**ADDENDUM NO. 2**

**Blossom Lake Park Improvements**

City of Seminole

January 18, 2022

**SITE & PHASING PLAN**

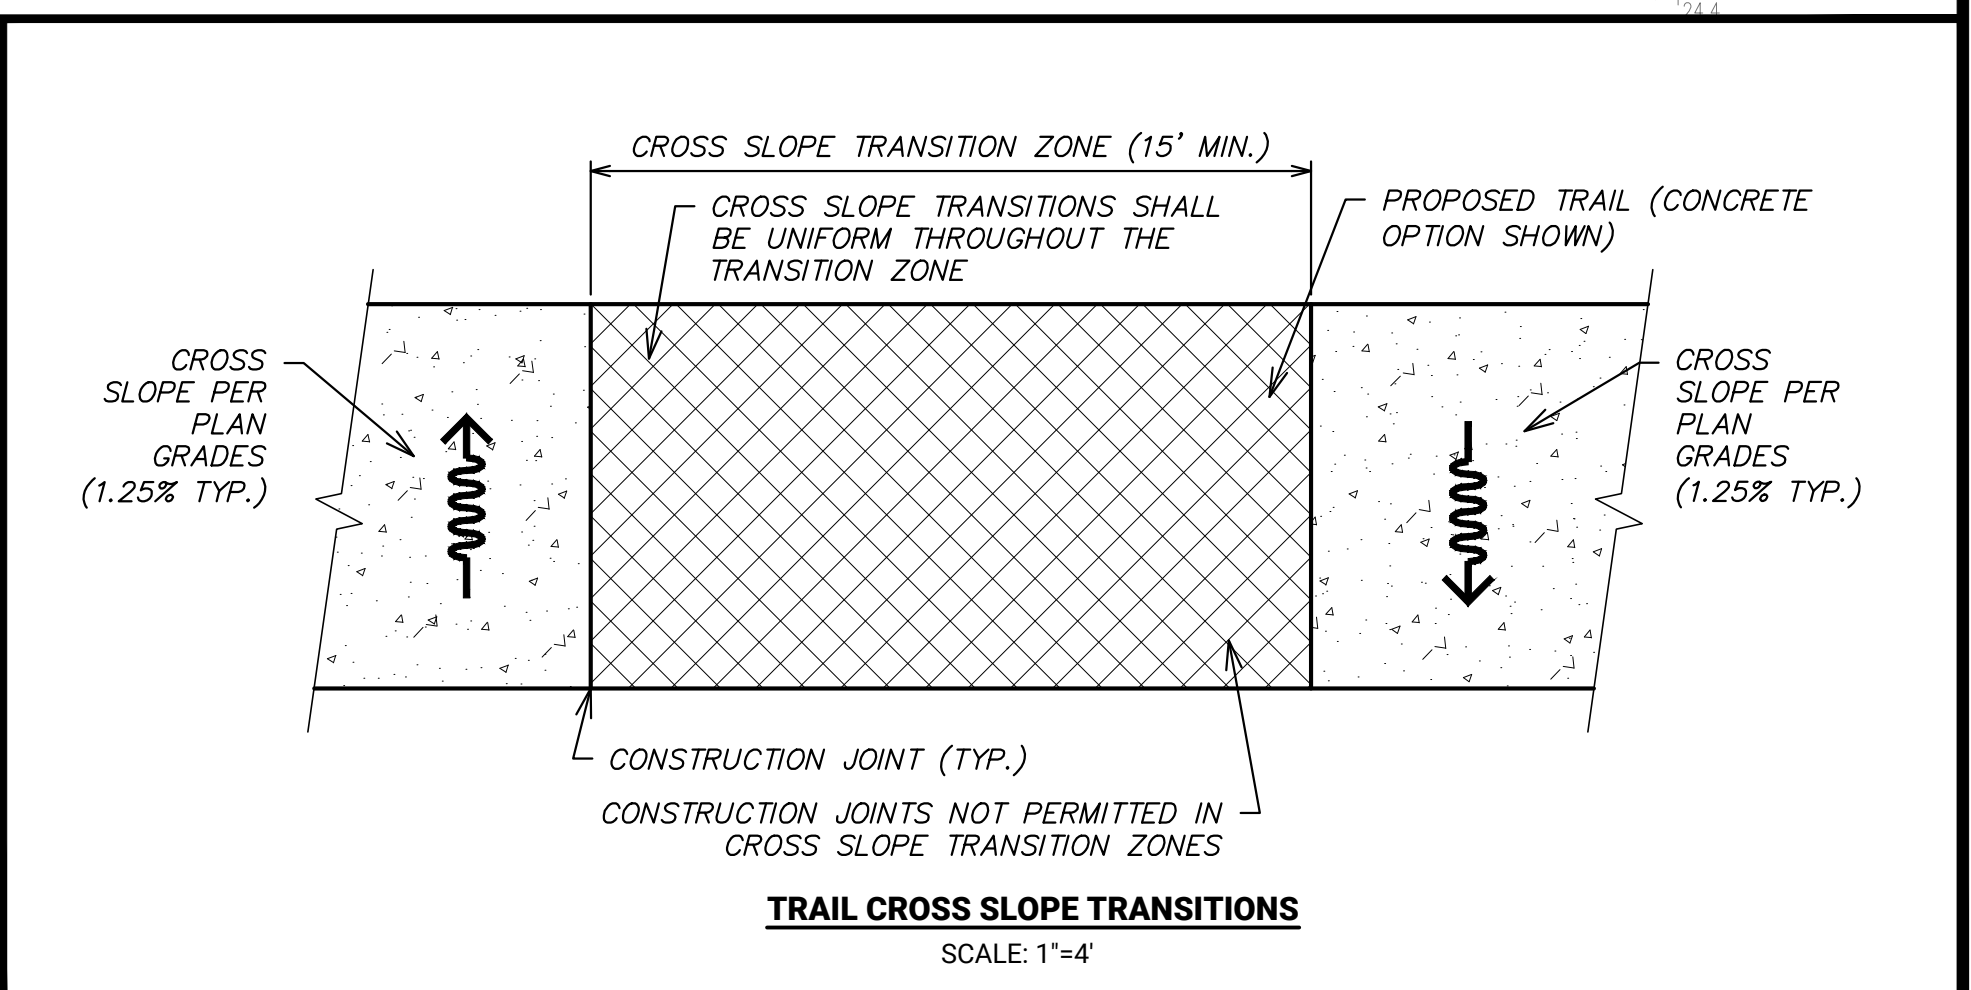
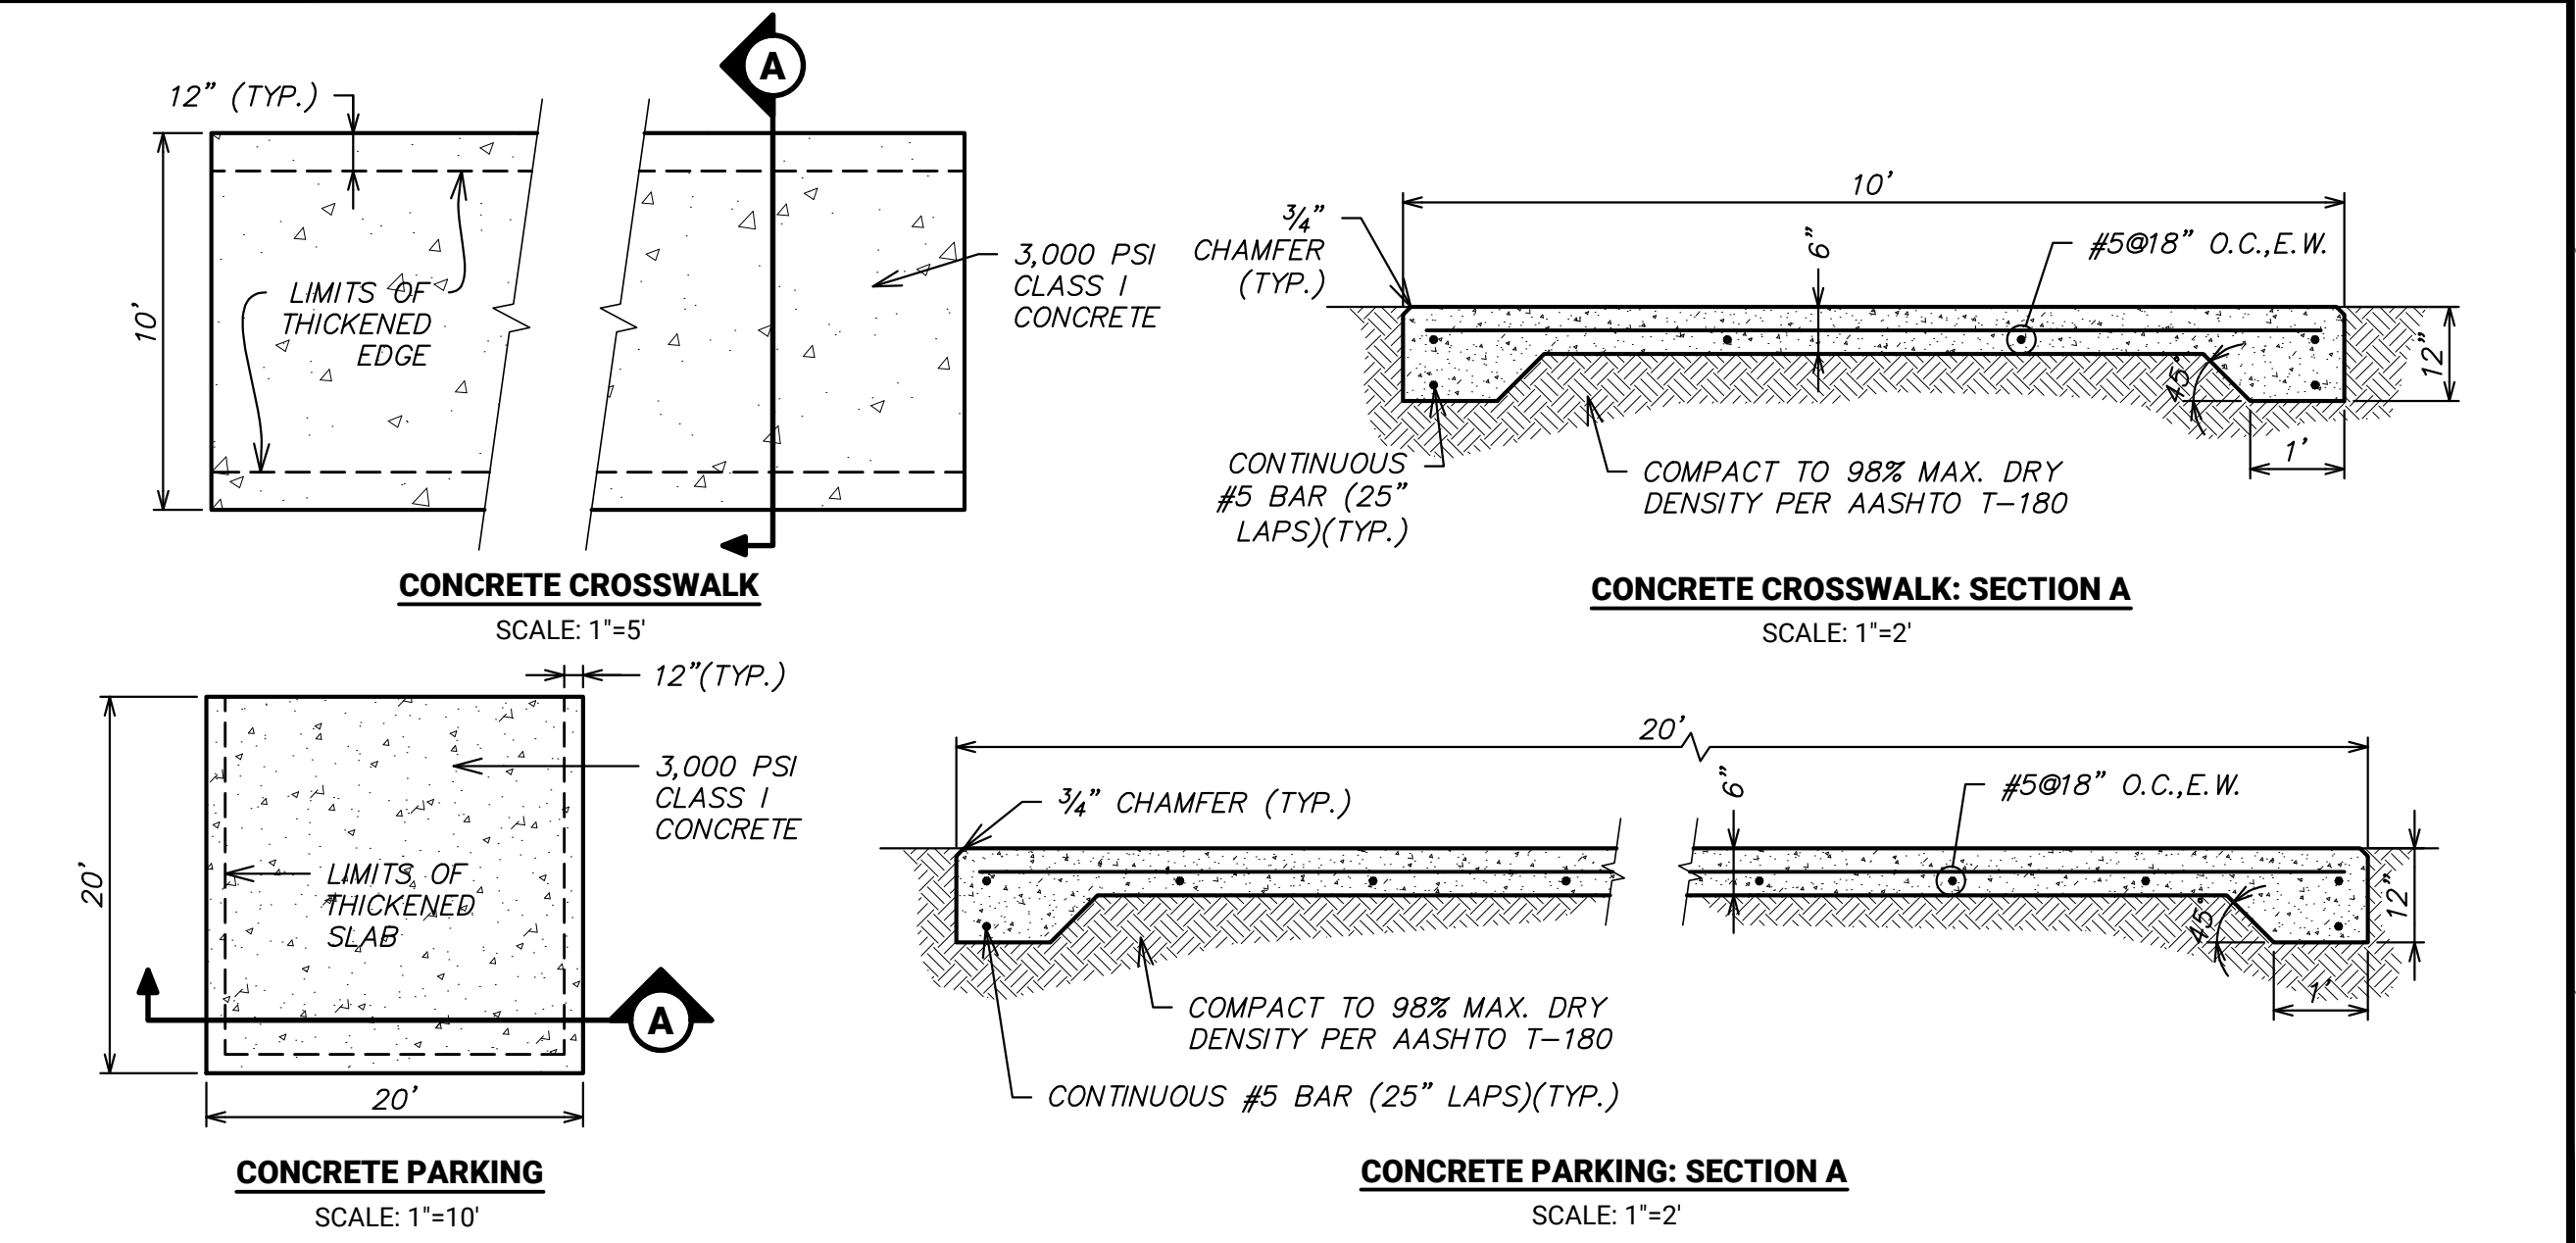
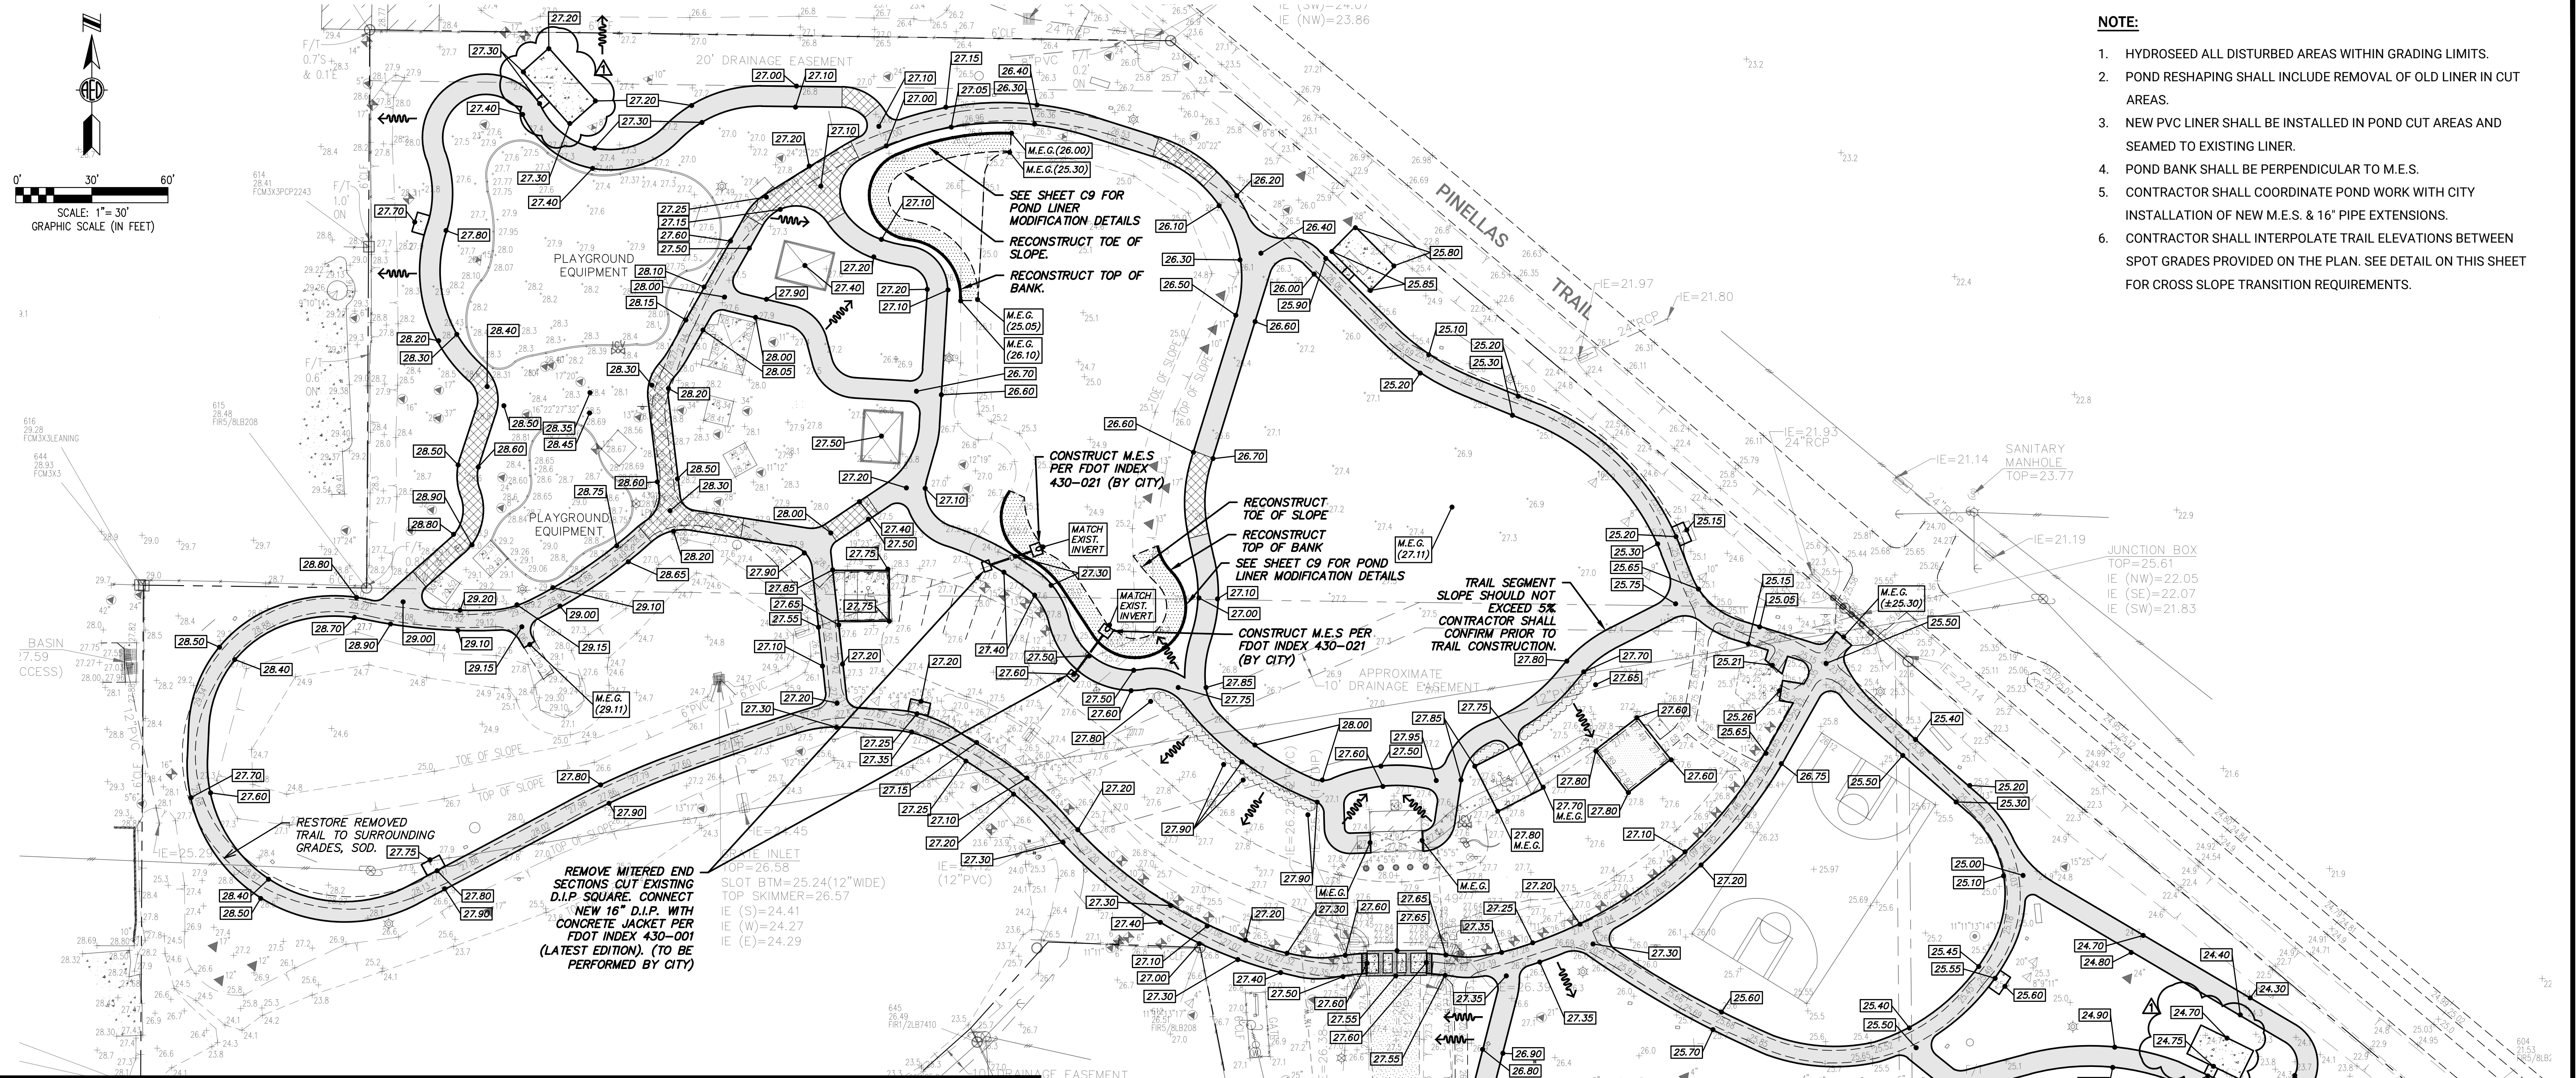
**A. Sheet C5, Site & Phasing Plan**

- a. Exercise Area 1 & 3 dimensions have been slightly revised to match the dimensions listed on Sheet C10 & C12.

**PAVING, GRADING & DRAINAGE PLAN**

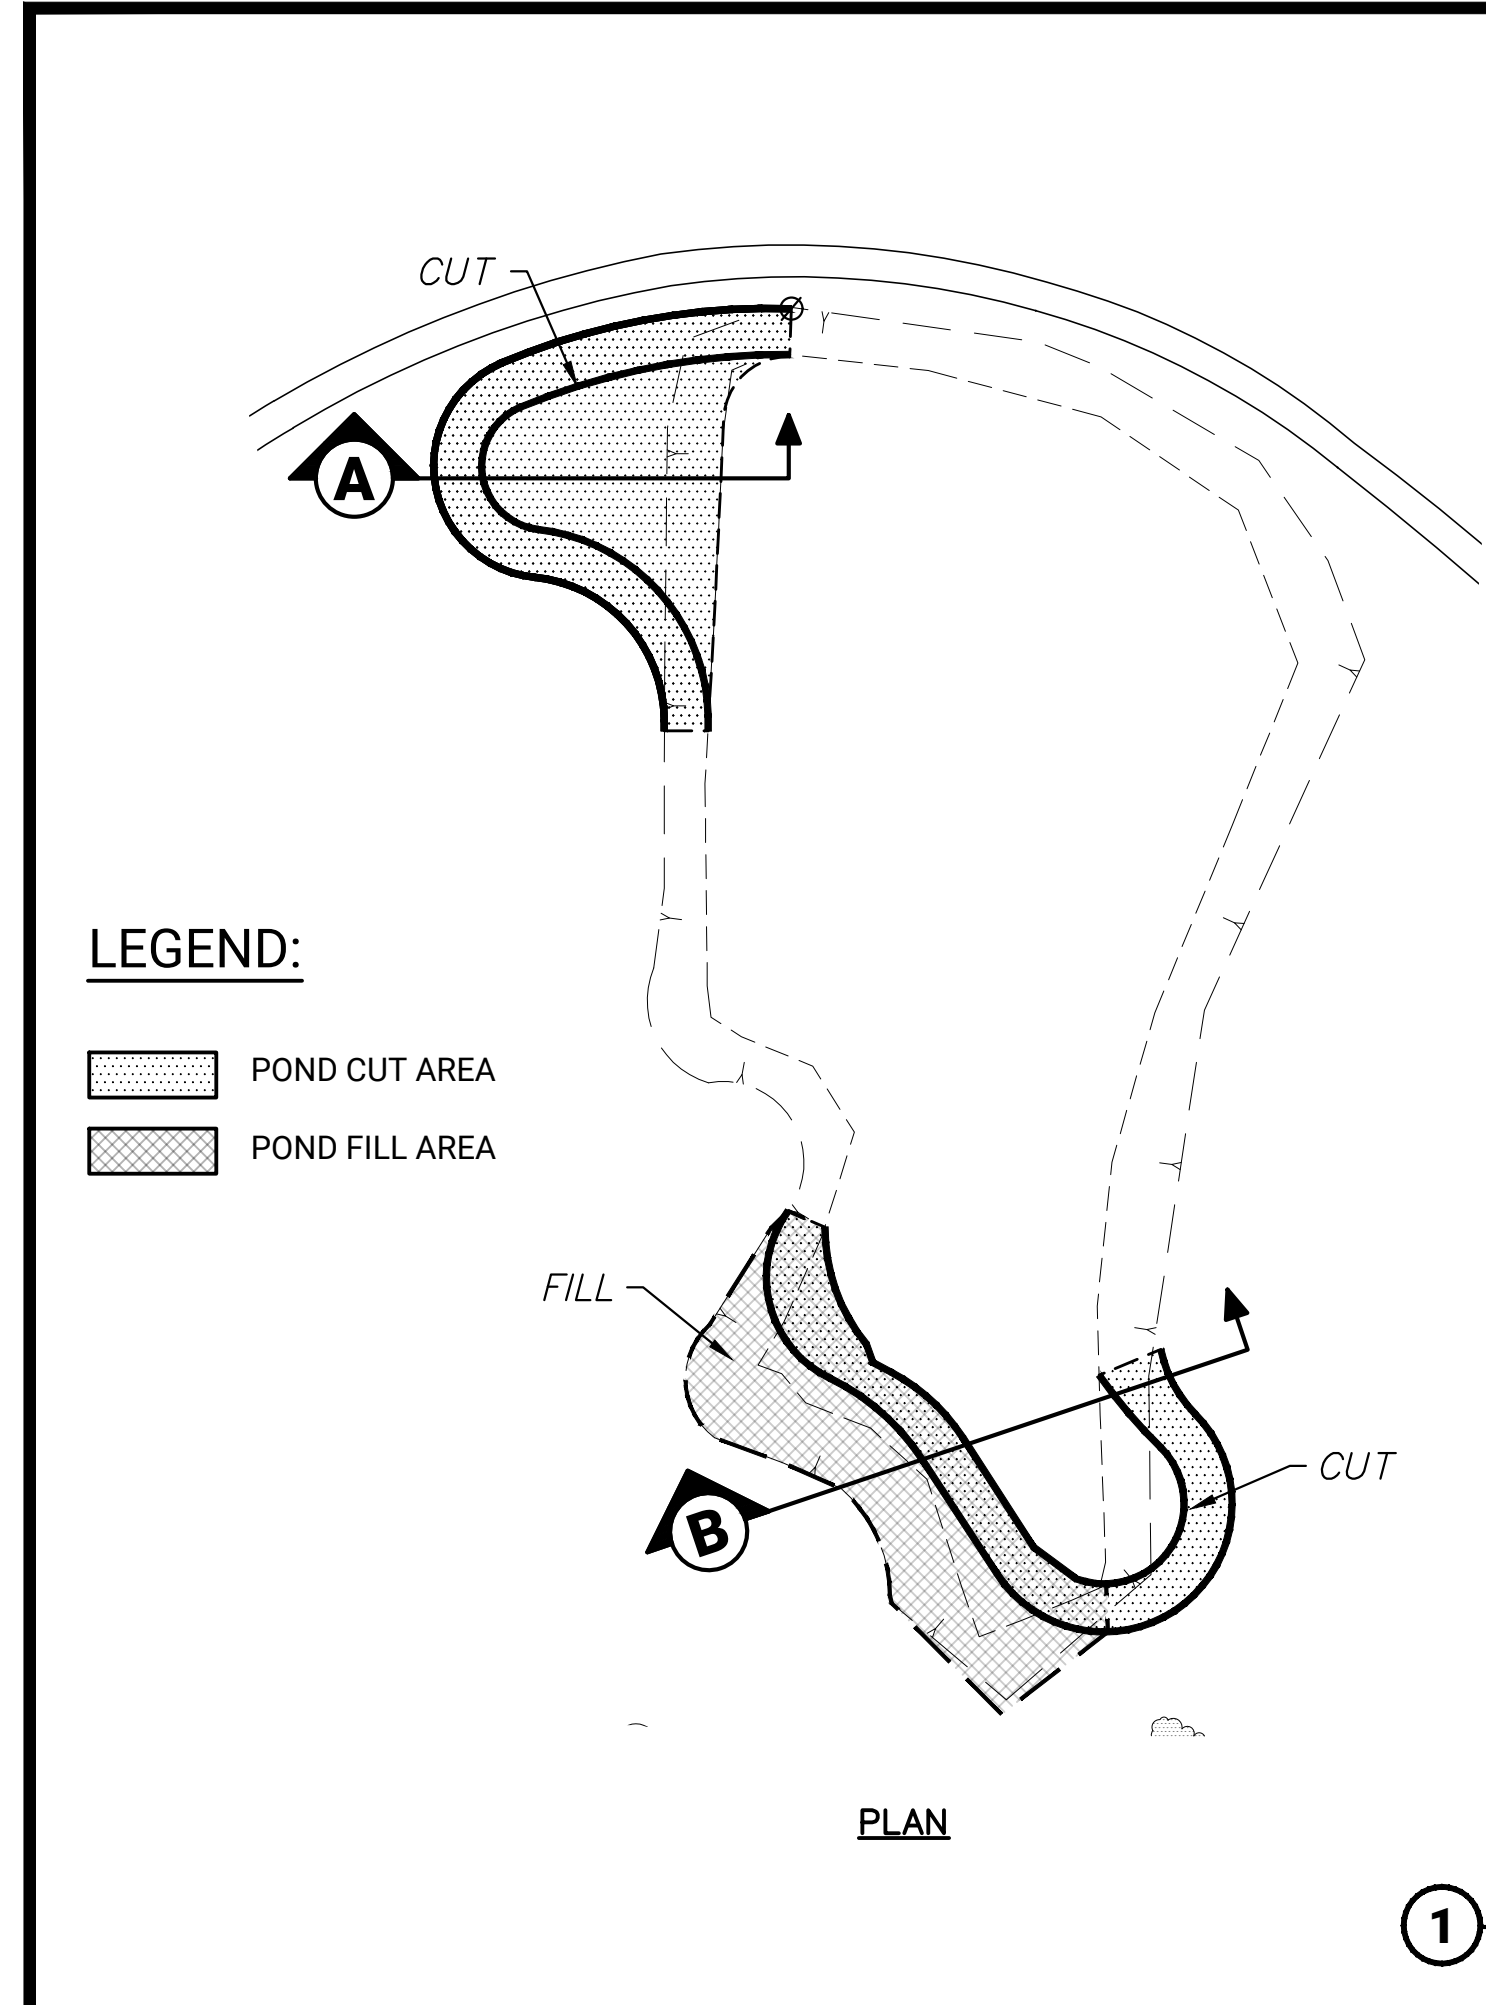
**B. Sheet C7, Paving, Grading & Drainage Plan**

- a. Exercise Area 1 & 3 dimensions have been slightly revised to match the dimensions listed on Sheet C10 & C12.
- b. Corresponding spot elevation locations have been adjusted to account for new exercise area dimensions (Area 1 & 3 only).
